## Hearing Examiner Staff Report and Recommendation

**Project Name:** Royal Valley Preliminary Plat

**Type of Application:** Preliminary Plat

**Permit Number:** 20-05572

**Figure 6 Project Site Plan**

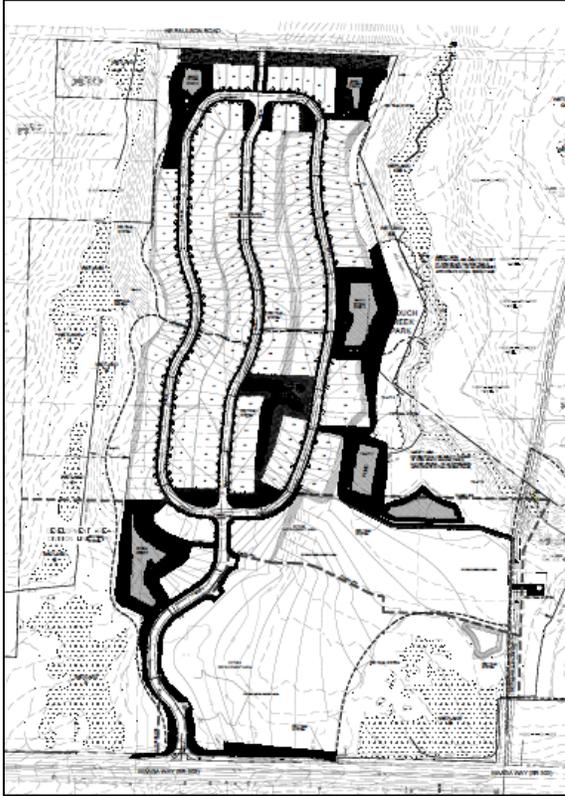
**Staff Comment:** *The proposal meets this standard. The applicant submitted revised preliminary drainage plans (Exhibit 1) and a drainage report (Exhibit 10). The proposed stormwater facilities include eight detention ponds for stormwater quantity control; and treatment facilities (Filterra units) for stormwater quality control. Development Services and Engineering reviewed the proposal and found the concept supportable in its approach to civil site development with recommended conditions of approval. Final engineered drainage plans are required to be submitted at time of SDAP approval and will be reviewed for compliance with Title 12.*

*\*Staff Comment: The landscaping separation for lots 22-26 is located within existing vegetation and critical area buffers to the west, however, this is not located on the subject parcel. A condition of approval #8 has been added to verify at the time of SDAP that this separation meets the intent of KCC 17.500.027.*

7. A final landscaping plan that meets the standards of KCC 17.500 is required to be submitted with the SDAP.
8. The landscaping separation required by KCC 17.500.027.B for lots 22-26 is proposed to be located within existing vegetation and critical area buffers to the west. If necessary, the director may require additional screening or fencing with the SDAP pursuant to KCC 17.500.027.
